Revision History

Schematics taken from P151-A00-X24 MS-8889 00A

1.c NV28 .. PLL / DAC / I2C

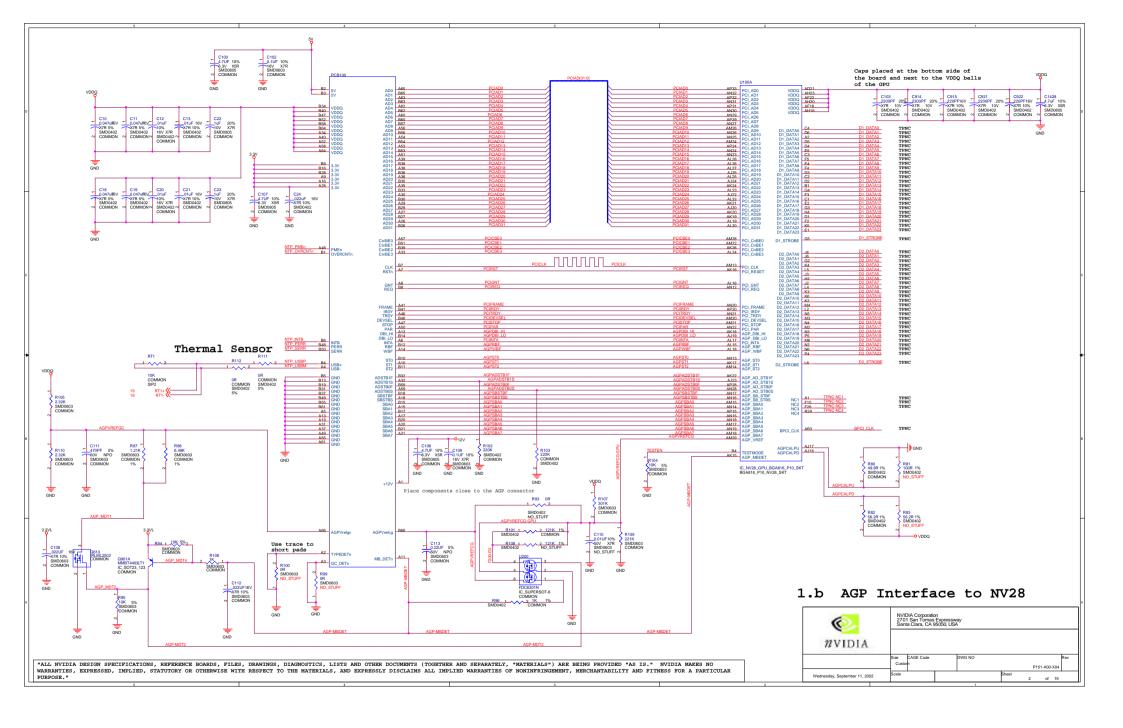
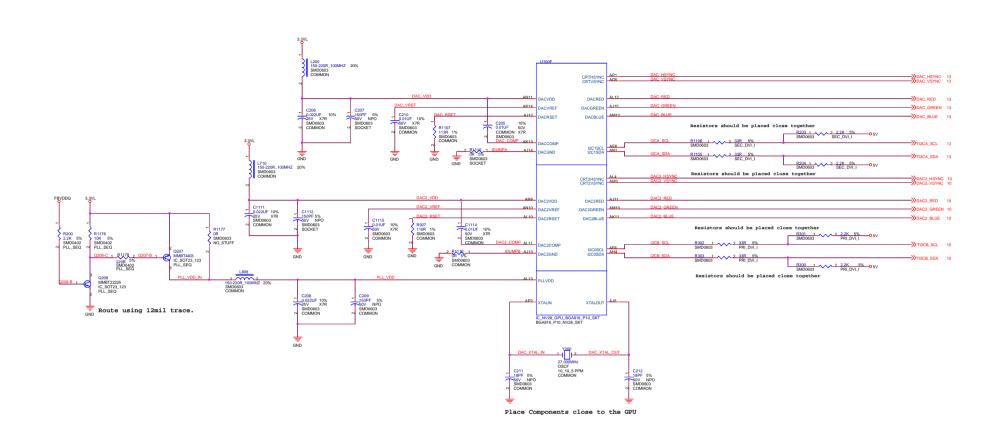
```
1)Page 16,17 - Remove C1263,C2267,C2301,C2303,C2309,C2310 for layout.
2)Page 16,17 - L801,L802 change Footprint to CHK_3052_08.
3)Page 3 - change R1107 to 113R and change R927 to 110R
4)Page 10.12 - C325.C320.C1120.C1121 from 22PF change to 47PF
```
